Environmental Health  
& Engineering, Inc.

February 28, 2013

**RE: PCB Removal and Disposal Work Plan Addendum, Garage Structure,  
100 Arlington Street, Boston, Massachusetts (EH&E 18257)**

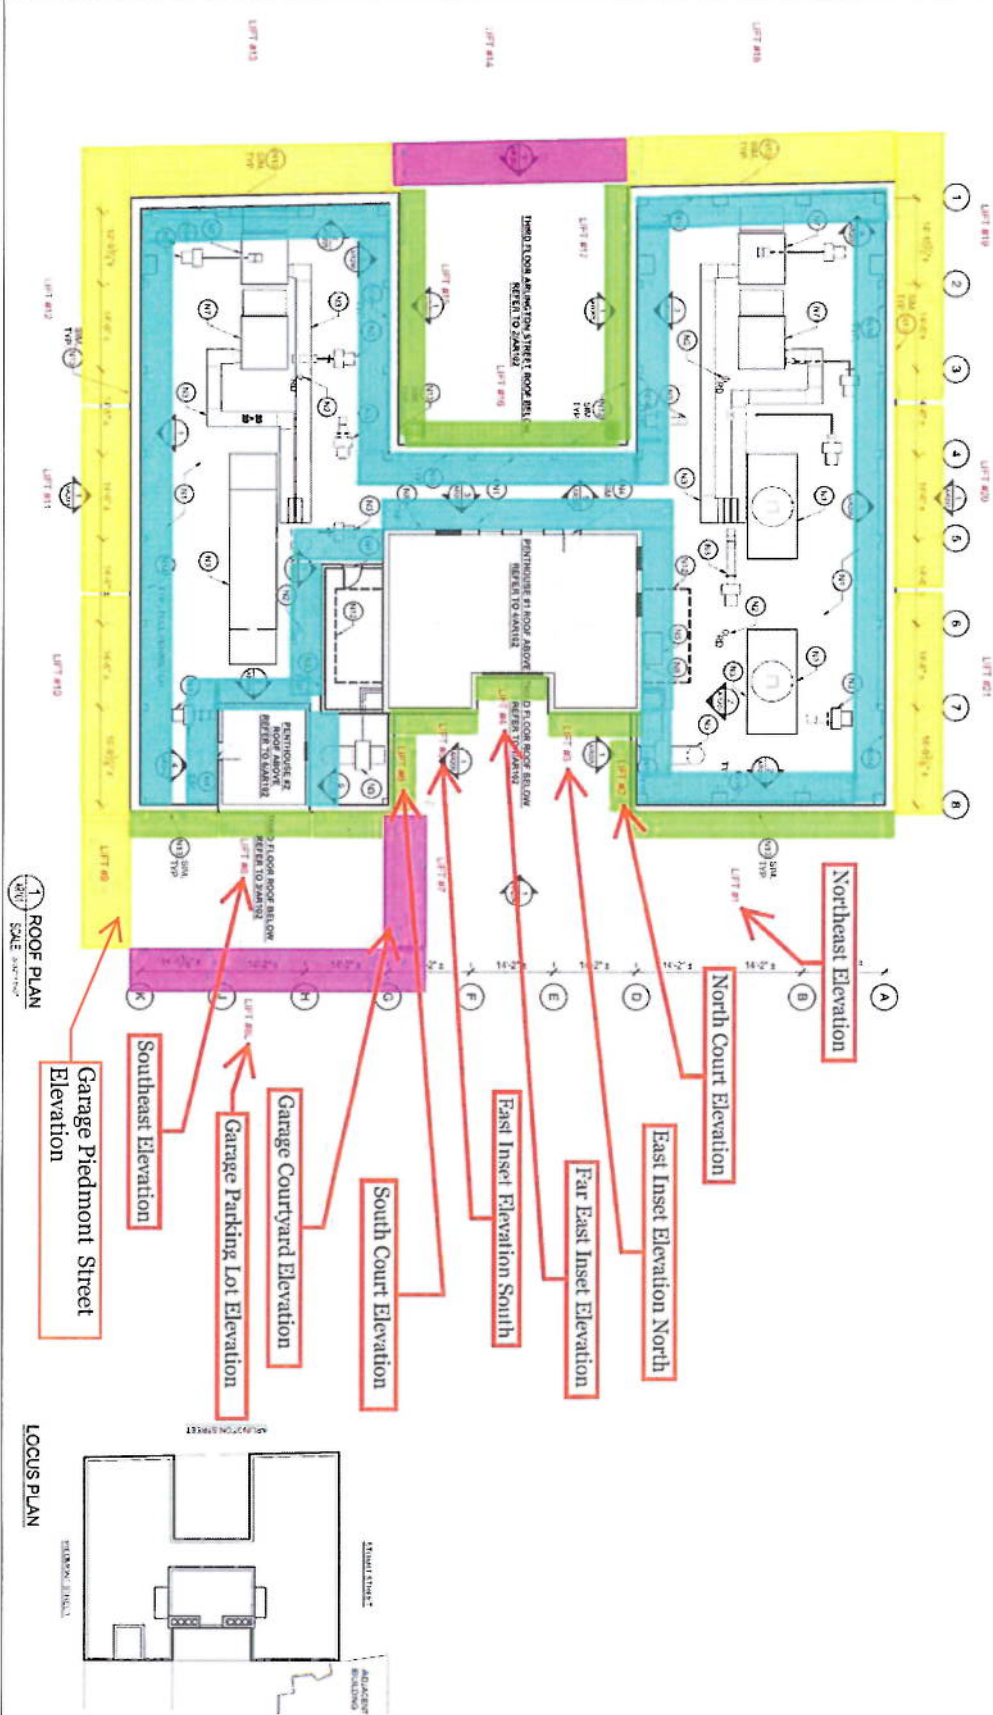
check  
Header Sample  
# 141097  
not in lab rep/  
Table + 1410979  
too many  
#5
